Access Compliance Report

Public Rights-of-Way

(Pedestrian Signals)

Intersection ID: N/A	Main Street:	Cross Street: N/A	Location: N/A
ADA ID: EC5223326946	Signal Type: One Push Button-APS	Overall Compliance: No	Severity Score: BTN 1: N/A BTN 2: N/A No BTN: N/A
Codes/Mitigation Info/Possible Solution		Field Measurements/Component Compliance

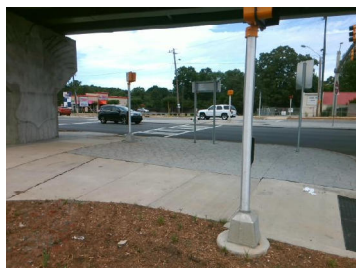
Surveyor Notes: THREE BTN ON ISLAND;
OTHER ADD BTN ID: 76A66C1D9E37

PROW/ADA: R404.2, R404.3, R406.2,
R404.7.3, R209.1, TMUTCD 4e.10, MUTCD
4e.10

Possible Solutions: Remove & Replace
Replace APS Button With New APS Button.
Remove and Replace Clear Space.
